# DETAILED CONSERVATION COMMISSION AGENDA

Date: Thursday, January 27, 2022

### 1. (7:00) 152 Suffolk Rd – NOI – backyard pool, sports court, patio, and greenhouse – DEP #239-911

**5. (8:15) Hammond Pond Parkway – NOI – roadway and corridor improvement -- DEP #239-???**

35  
 326 Fuller  
 BraeBurn Country Club  
 Revised Plan  
 1/27/2022 meeting

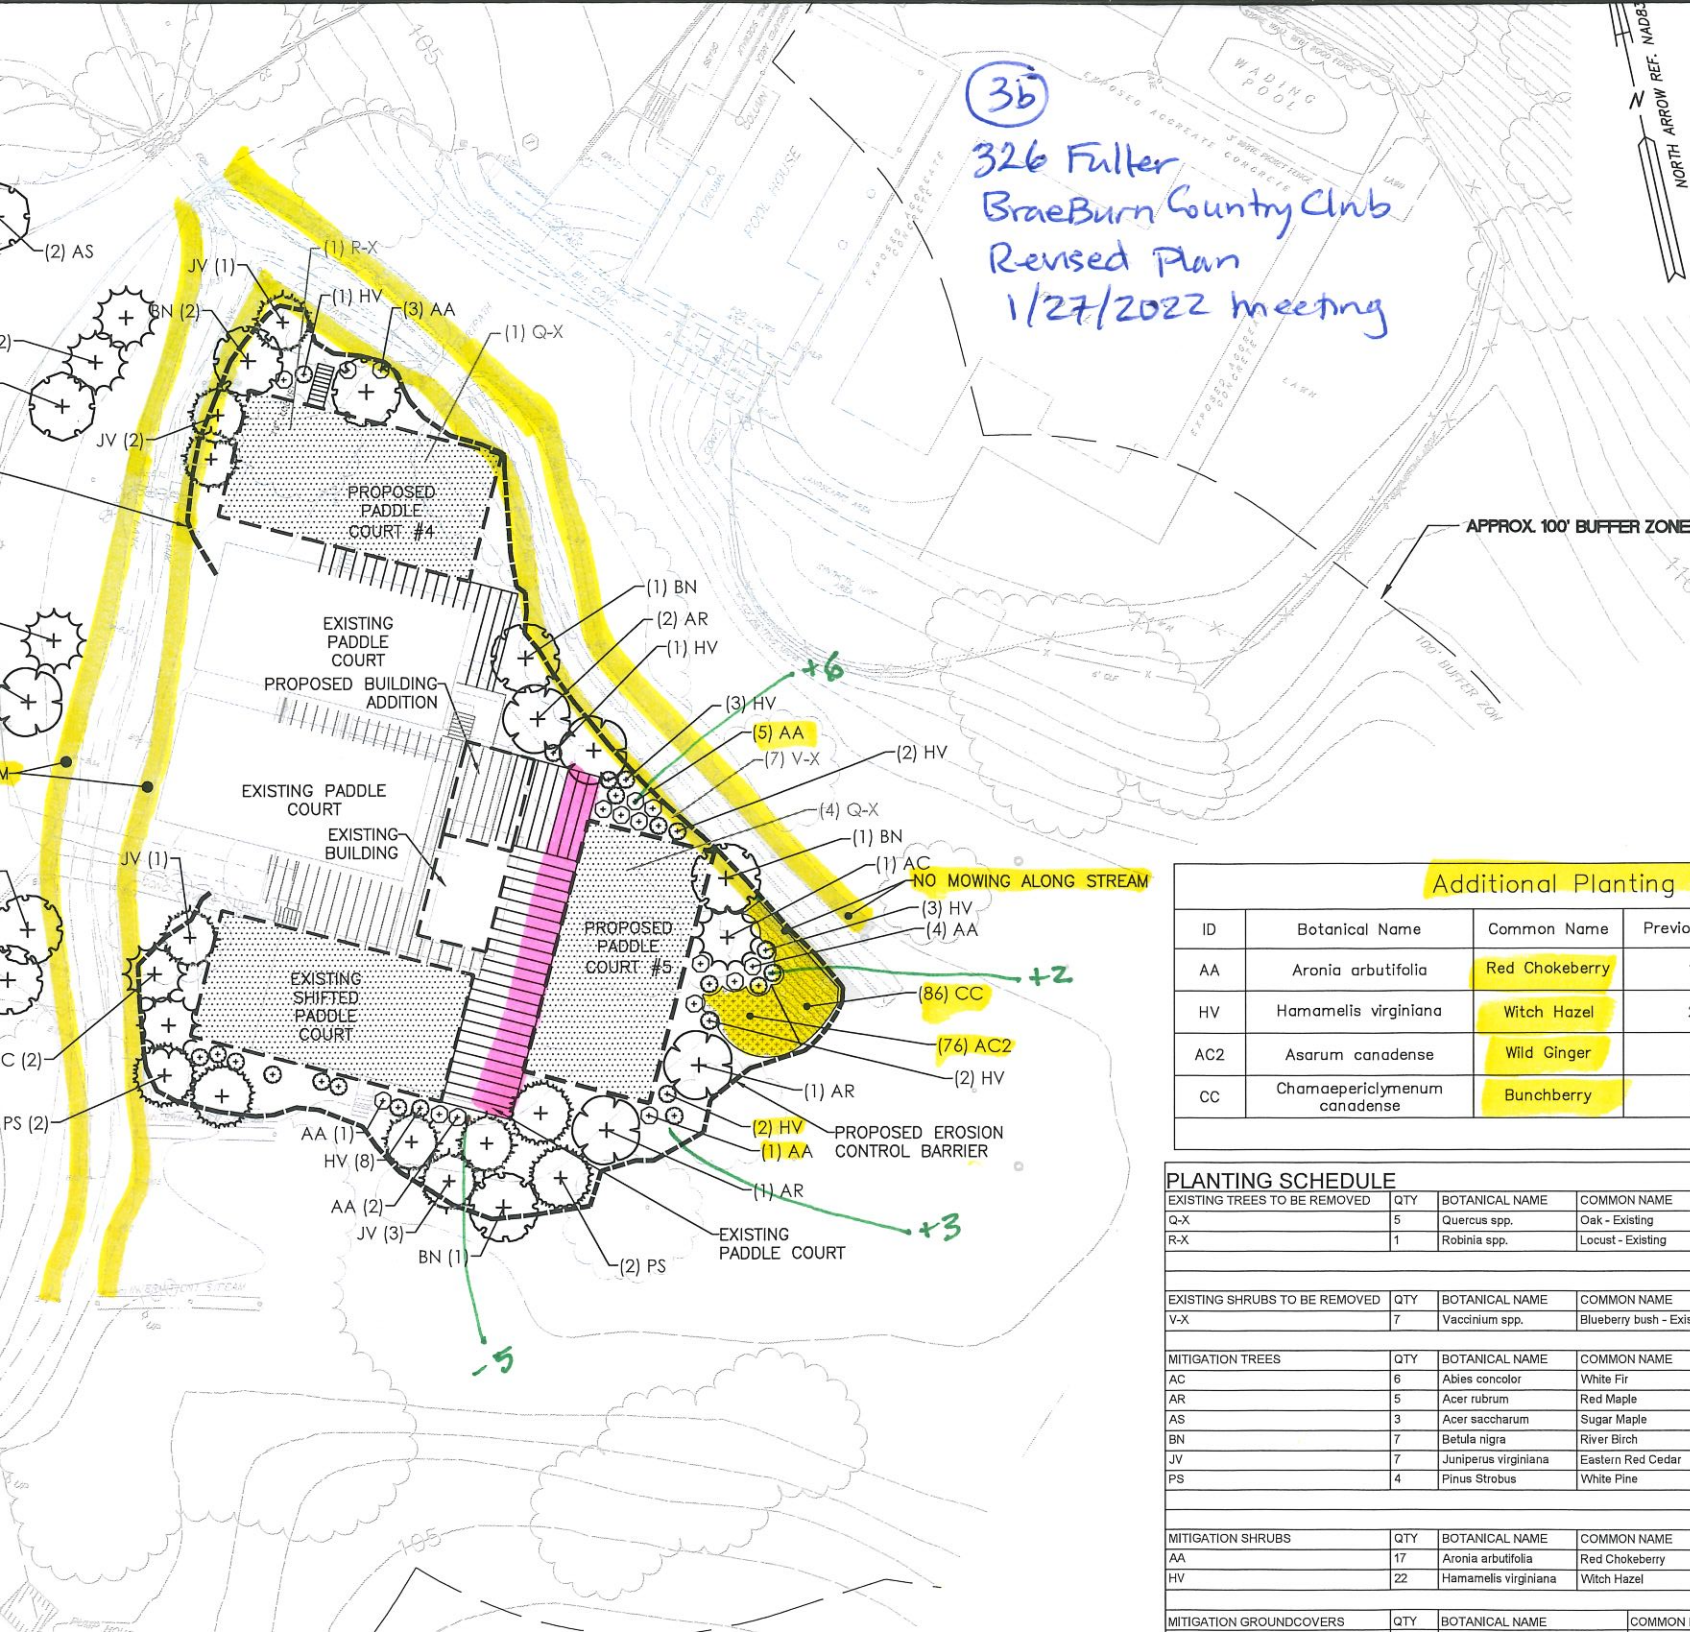
- Expand the viewing deck by 10' in width (from 6' to 16'), resulting in: 850 sf of additional "developed" area; and
- Shifting of one of the new paddle courts 10' to the east and 5' to the south

- To balance the proposed deck expansion, the applicants have proposed: increasing the size of the mitigation planting area a bit, moving proposed plants to accommodate the new layout, adding:

- 6 native shrubs (4 additional Red Chokeberry, 2 additional Witch Hazel),
  - ground cover (76 or 92 wild ginger and 86 or 104 bunchberry), and
  - a 4' no-mow strip along the banks of the streams that surround the paddle court area.

- Staff Notes: The proposed mitigation enhancements seem to offer appropriately robust enhancement of the buffer zone and increased protection of the adjacent intermittent streams.

- Staff Recommendation: Vote to approve the proposed changes as Minor Plan Changes, to be documented in a memo and reflected in the required as-built plans.

## Mitigation Plantings on the Locus Site

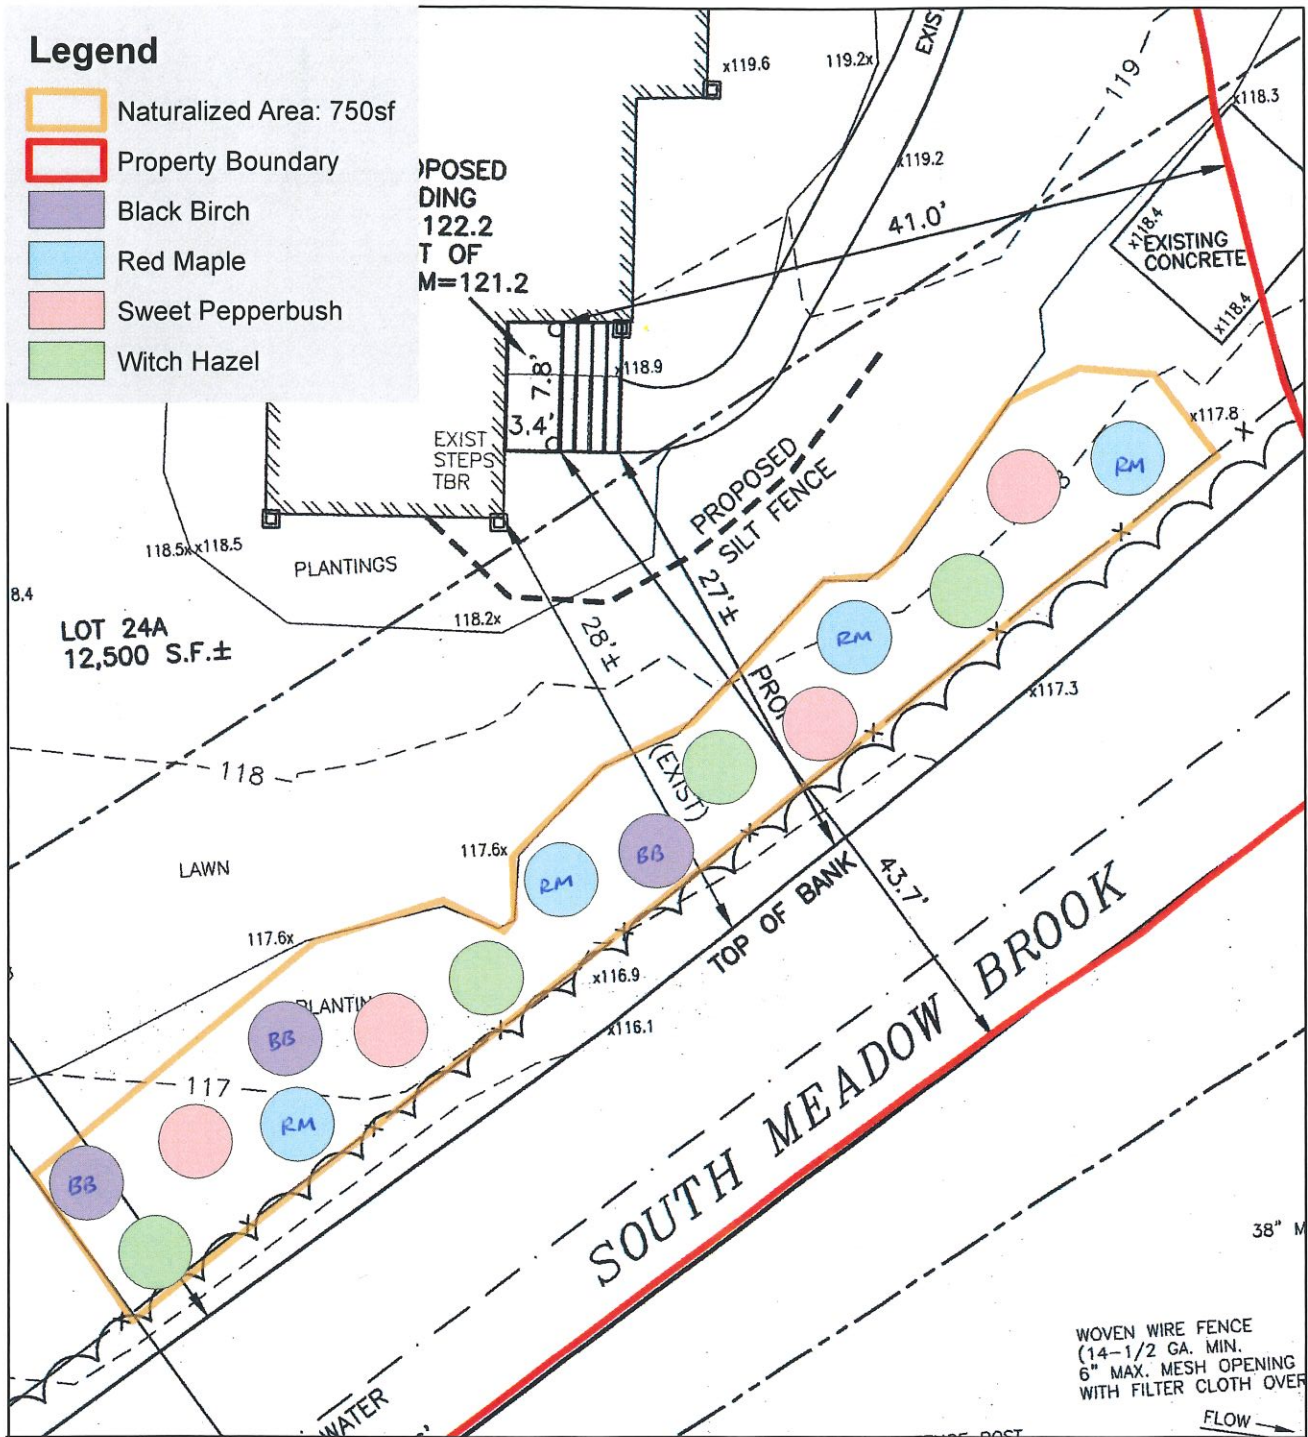
- Staff Notes: Modified plans address most staff questions and concerns.
  - Permanent bounds (either rebar with mushroom caps or granite or concrete posts) are now proposed for the corners of the mitigation area. The Commission should consider whether those should be shifted to the "middle" of the bounded are or added to to ensure long-term protection of the mitigation planting area.
  - Locations of mitigation trees and shrubs have been modified and appear to be more-or-less appropriate.
  - 2 saplings are now proposed in the "adjacent lot" as requested. The City's Forester has noted that the "adjacent lot" does not appear on lists of City-owned land.

- Mitigation area will have any invasives removed and then be seeded with New England Wetland Plants Conservation Mix to stabilize the soils. Applicant should clarify what non-natives have been identified for removal, since there are Norway maples and some non-native shrubs in the area.

- Staff Recommendation: Vote to close the hearing and issue an OOC with the following special conditions:
  - The new wood stairs may not be fully enclosed, per the Commission’s Flood Storage policy.

- Spaces between deck boards and stone under the deck are required to ensure infiltration.
  - Old mulch just beyond the fence line must be removed to allow natural revegetation of the stream bank.

- No new loam or sod has been identified on the plans and no new loam or sod may be brought on to the site because of flood storage concerns. Scarification prior to (re)seeding is recommended.

- 2? 3? bounds must be set along the front edge of the mitigation area, at least 2.5 feet deep with at least 6” above the finished surface grade and must note words to the effect of “Conservation Area, Do Not Disturb”
